TITLE: PUBLIC HEARING: Subdivision Permit and Plat for The Life, Laramie County, WY.

PZ-25-00064

THE LIFE
SUBDIVISION

Permit Number: PZ-25-00064

THE LIFE

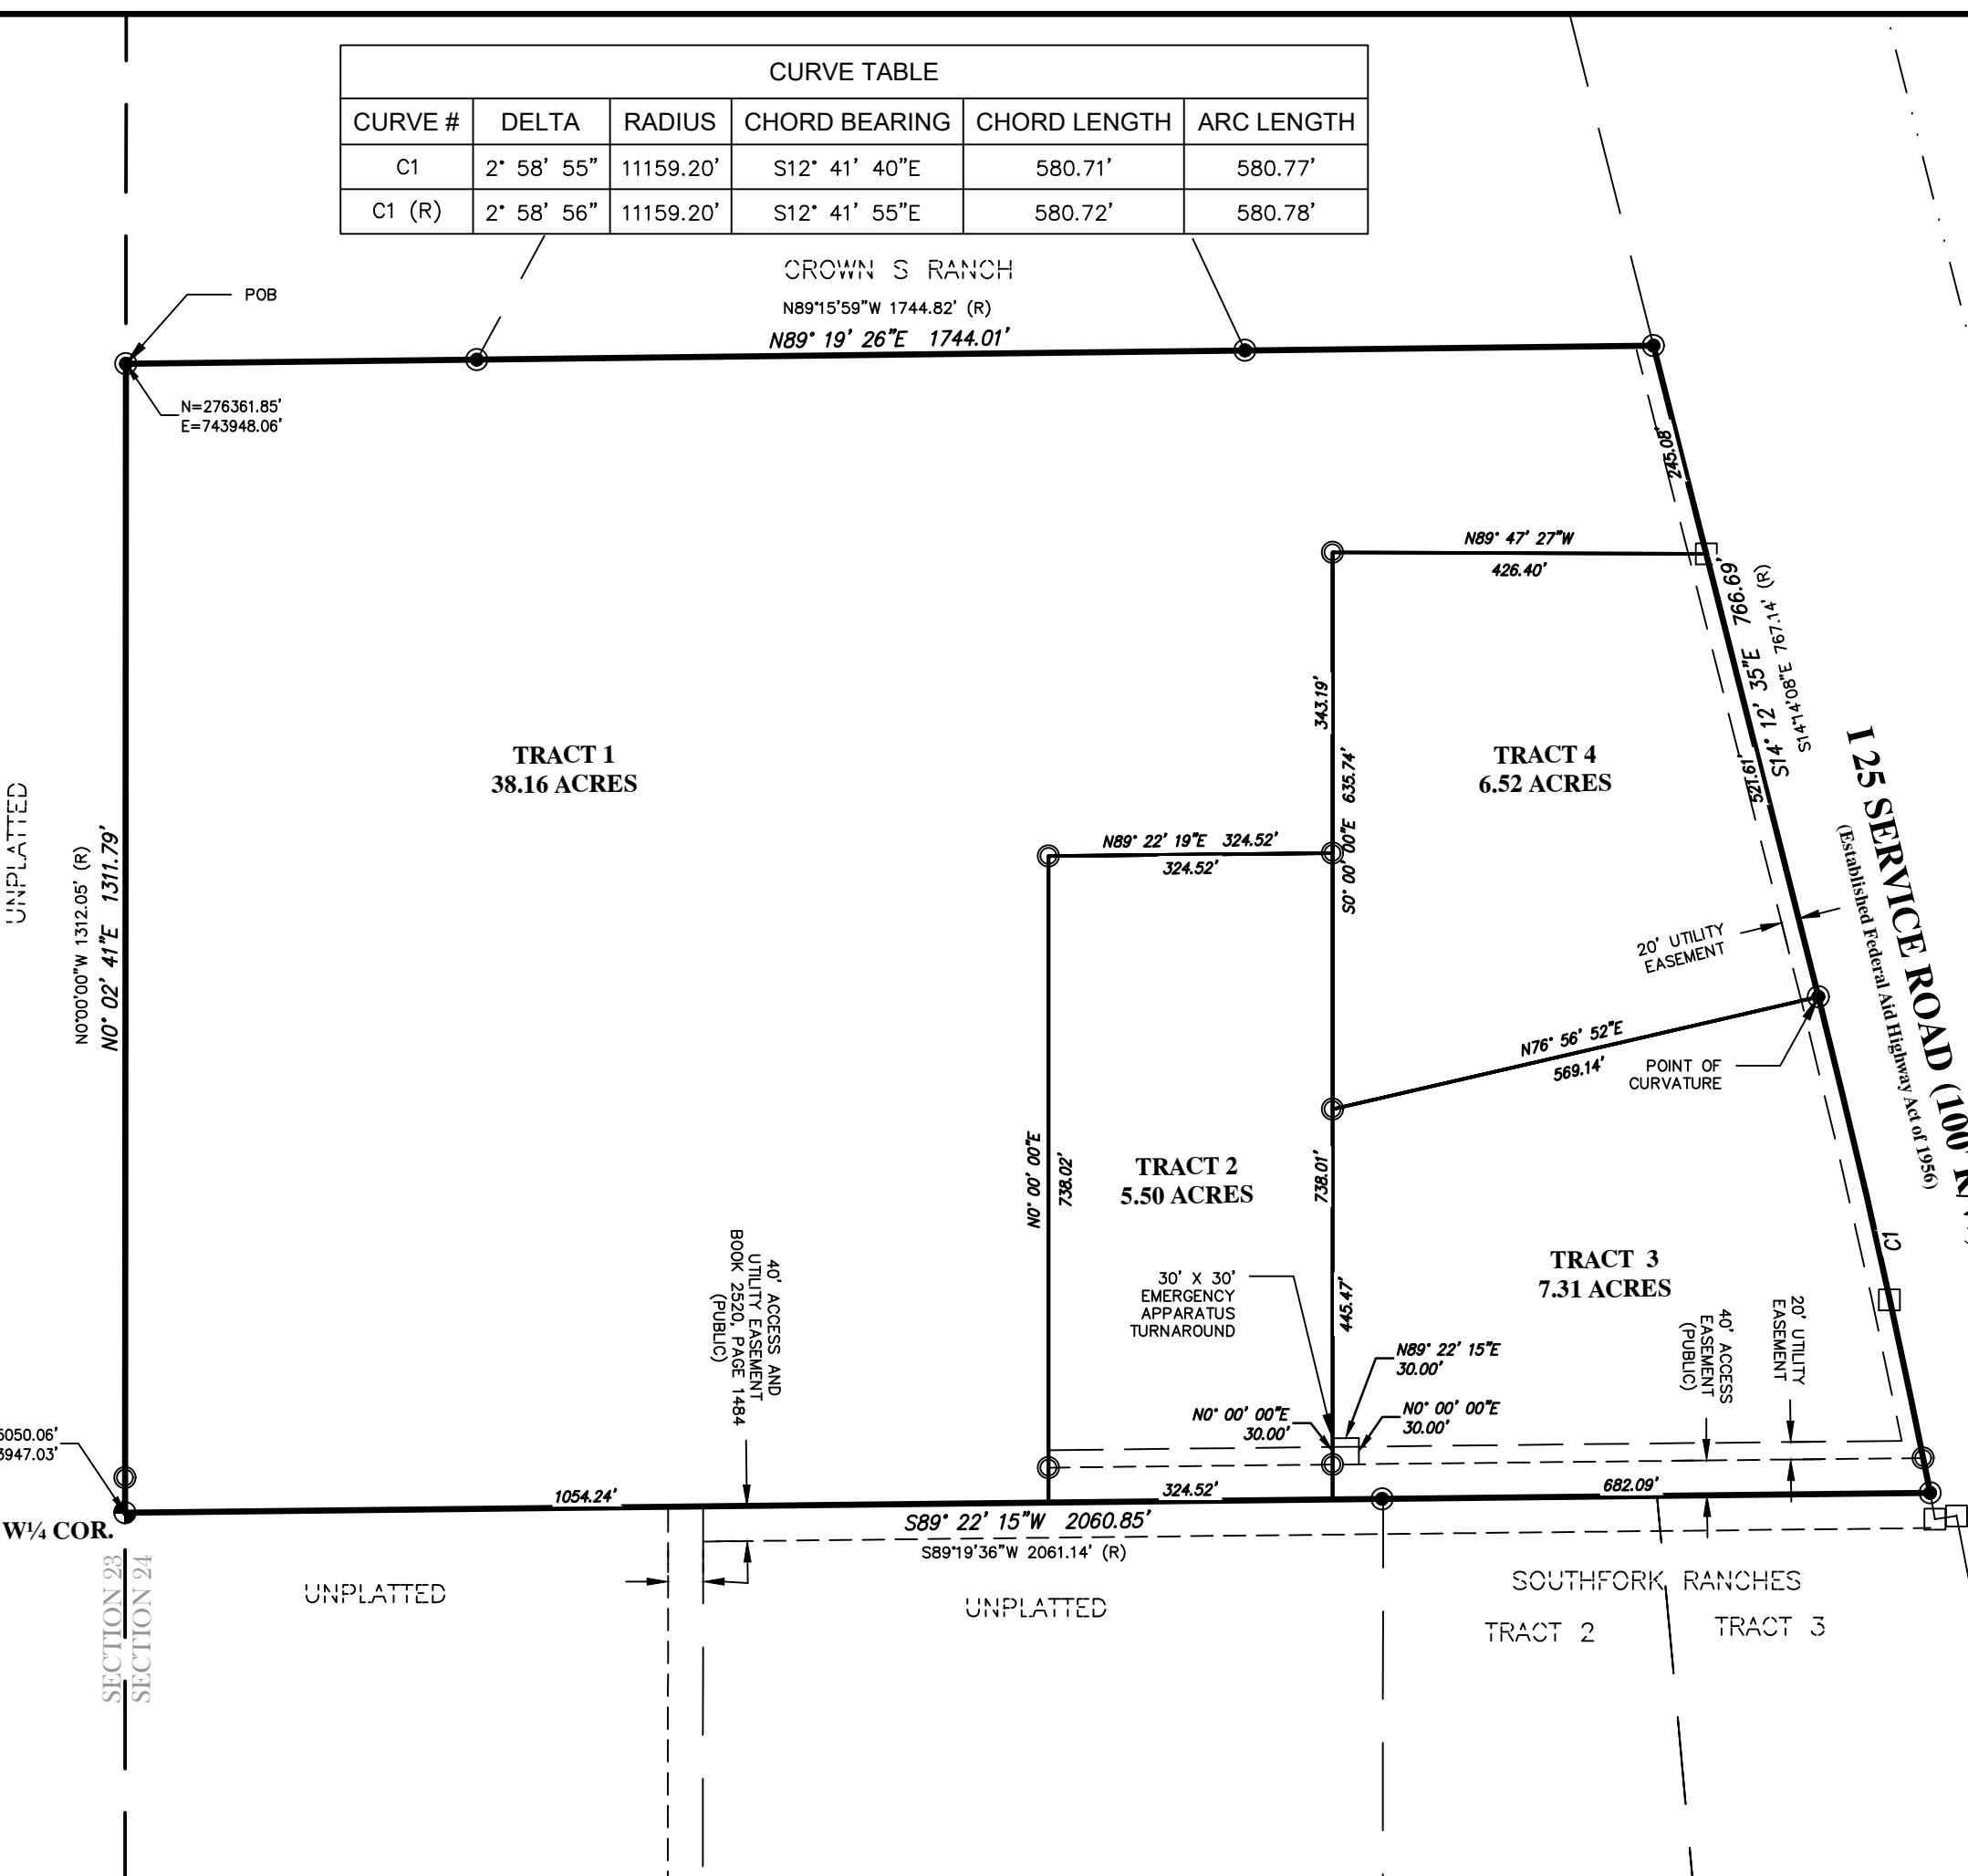
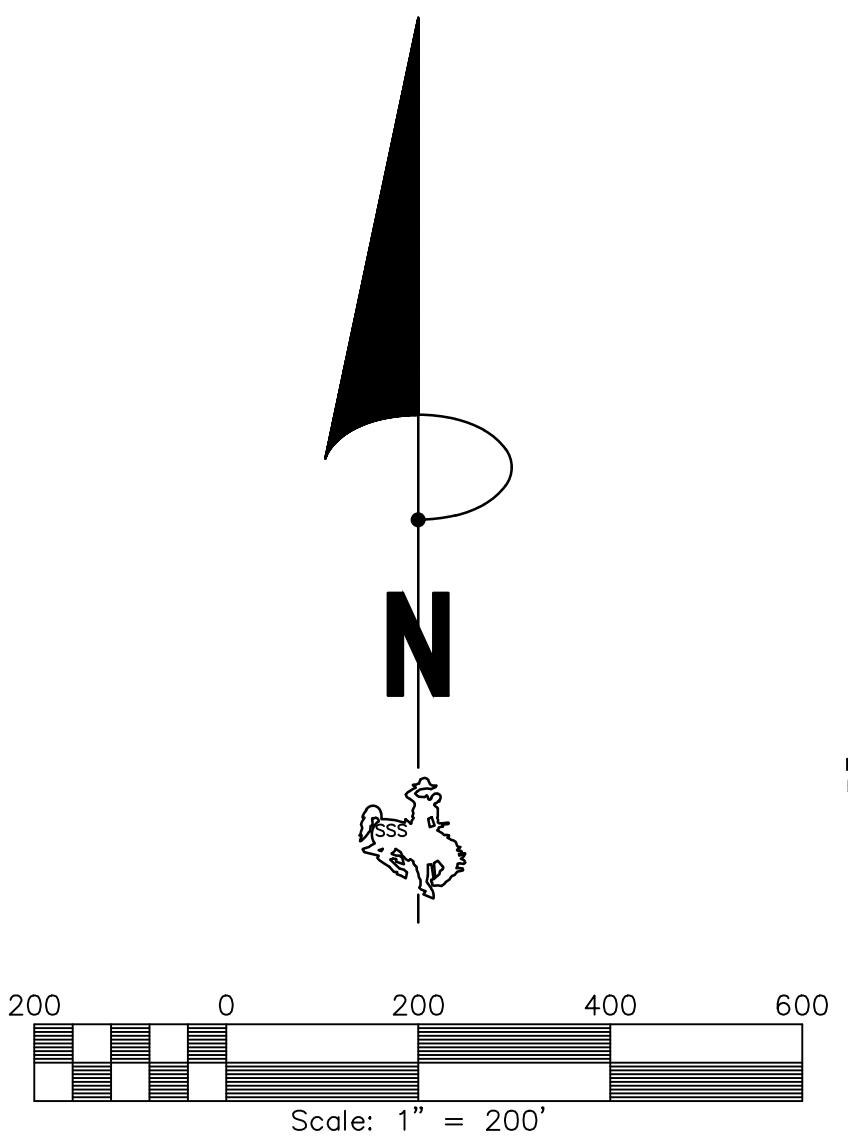
5.It appears, based on WYDOTs spacing criteria, that only Tract 5 could possibly have an access off the I25 Service Road and all other Tracts shall access via a new dedicated ROW. Tract 5 also appears to be for the existing residence that currently is using an access road that goes through Tract 4. Is it intended to create a new access road for Tract 5 off the Service Road?

6.Per 4-5-102.c. the plat drawing shall include the following items: 14.) Plats that show adjacent or internal existing roadways and rights of way shall indicate on the plat how the roadway was established (i.e., dedicated to the public via plat, petition, declared, etc.). How was the I-25 Service Road established? 21.) A legend that defines all the various symbols, line types, shading/hatching, etc. used in the drawing. The legend shown on the plat only defines symbols, but not line types.

7.The Tract numbers for Tracts 2 and 3 of the Southfork Ranches should be labeled on the plat drawing.

1.Per 4-5-102.c. the plat drawing shall include the following items: 4.) Dedication and acknowledgment statements must be executed by all owners of legal and equitable interests in the property being subdivided/developed. The acknowledgement shall be located near the dedication on the plat. The dedication of right of ways and easements is mentioned in the DEDICATION, however it does not define if

they are dedicated to the public or for any other purpose. 10.) For subdivisions in the County, survey tie(s) by bearing/azimuth and the distance to the nearest public land survey system monument shall be accurately described on the plat. In addition, for the purposes of enhancing the City and County GIS Program framework, all public land survey corners on or within the subdivision boundary shall have field observation coordinates provided on the plat. These coordinates shall reference Wyoming State Plane Coordinate System, East Zone, U.S. Survey foot, NAD 1983(CORS96). The coordinates shall be observed and verified at the time of the plat survey. There are no Wyoming State Plane field observation coordinates shown on the plat. 16.) Where applicable, curve data showing the radius, central angle, arc length, chord bearing/azimuth and distance and any notation of non-tangent curves. The location of points of curvatures and intersections shall be shown. The point of curvature for the curve on the east boundary of the subdivision should be shown. 18.) The right-of-way lines, widths and names of all streets, roads, and easements within and adjacent to the proposed subdivision/development. What is the width of the I-25 SERVICE ROAD portion of I-25?

4.Per 4-5-102.c. the plat drawing shall include the following items: 14.) Plats that show adjacent or internal existing roadways and rights of way shall indicate on the plat how the roadway was established (i.e., dedicated to the public via plat, petition, declared, etc.). How was the I-25 Service Road established?

5. Per WYDOTs comments and per the County (i.e., in general developers should utilize internal roadway networks whenever possible and in this case there is no reason Tract 1 would need access off the service road), Note 6 needs to be changed to indicate Tracts 1, 2 and 3 shall be accessed off the roadway in the easement and only Tract 4 shall access from I25 Service Road.

<p>1. ack</p> <p>2. ack</p> <p>3. ack</p> <p>4. ack</p> <p>5. the note will remain as is. We have wydot approval per taylor mccort.</p>
